**PRODUCT BULLETIN # 16746**

**TITLE:** Change packing standard by removing protective band from plastic reel at ON Semiconductor (Thailand).

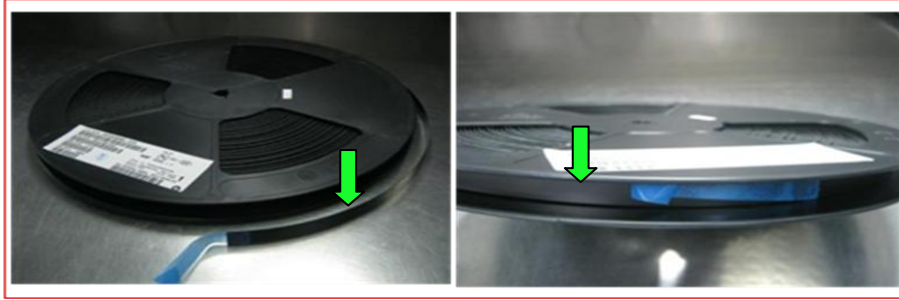
**Before Change:** The protective band covers the reel then closes the end by Blue ESD tape.

**After Change:** Blue ESD tape closes the end of the reel packing.
